# Shipra Fashion Ltd (Extension)

## Structural Inspection Report

- Single storied Production Shed.

Base plate

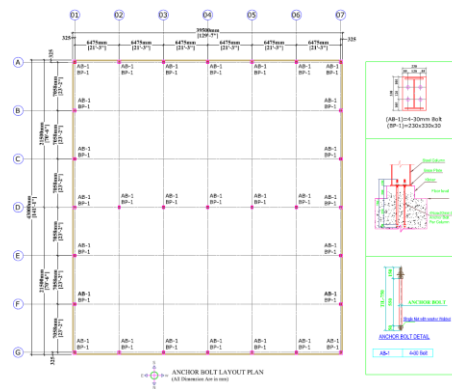
**Description:** During inspection, mismatch was found in steel column base plate size and roof bracing identification.

- Base plate size was found 280 x 200 mm instead of 330 x 230 mm.
- Roof bracing was found 16 mm rod bracing in mid part shown in figure which was not mentioned in drawing.

The building engineer is required to update the drawing and design documents based on the as-constructed structure.

Roof Bracing

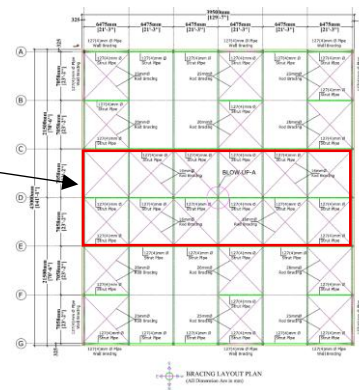
16mm  
rod  
bracing
